UNITED STATES PATENT AND TRADEMARK OFFICE

APPLICATION NO.	FILING DATE	FIRST NAMED INVENTOR	ATTORNEY DOCKET NO.	CONFIRMATION NO.
10/024,656	12/17/2001	Amir Belson	BEL1020U	2664
25197	7590	08/25/2004	EXAMINER	
LEARY & ASSOCIATES 3900 NEWPARK MALL RD. THIRD FLOOR, SUITE 317 NEWARK, CA 94560			QADERI, RUNA S	
			ART UNIT	PAPER NUMBER
			3737

Office Action Summary	Application No. 10/024,656	Applicant(s) BELSON ET AL.	
	Examiner Runa S. Qaderi	Art Unit 3737

Oz discloses an optical viewing system for viewing areas to be examined which are difficult or extremely awkward to view. Figure 1 of Oz below diagrams the optical viewing system configured to be mounted on the user's hand, more preferably on the

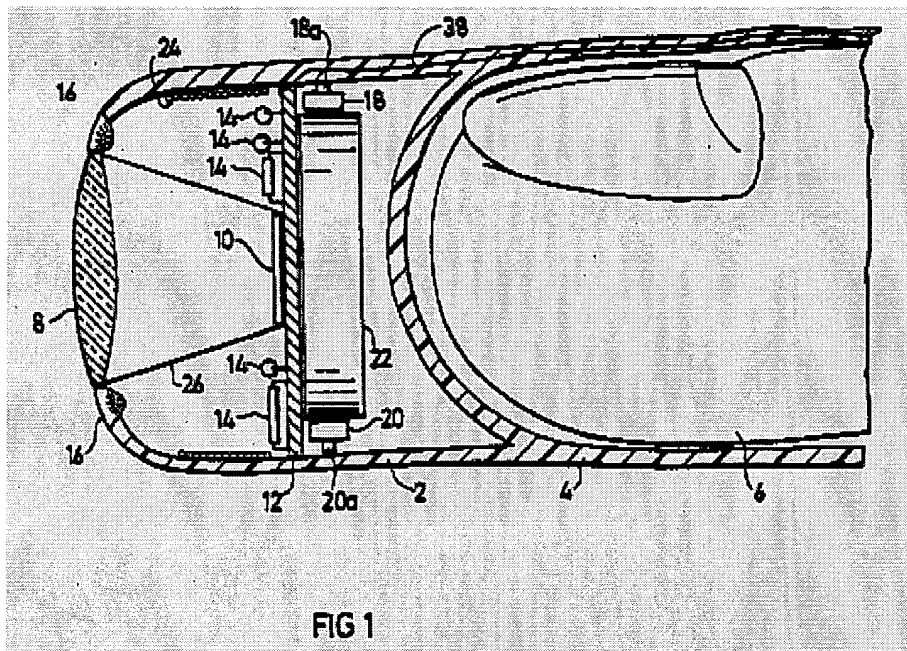
user's finger. The optical viewing system comprises a light source (16) for illuminating the space in front of the focussing lens (8), an image sensor (10) for receiving the optic image focused onto the lens (8) and transforming the image into electrical signals. The image sensor is a CCD, commonly used in solid-state television cameras. A remote unit (figure 2) includes a unit (46) for displaying the image sensed by the CCD image sensor (10). Figures 1 (below) and 6a, 6b, and 6c of Oz satisfy the applicant's limitation to tapered distal and proximal end for ease of insertion. The teaching to mounting on the finger of the user satisfies the applicant's limitation to mounted on a ring because a ring is interpreted as configured to be mounted on a finger.
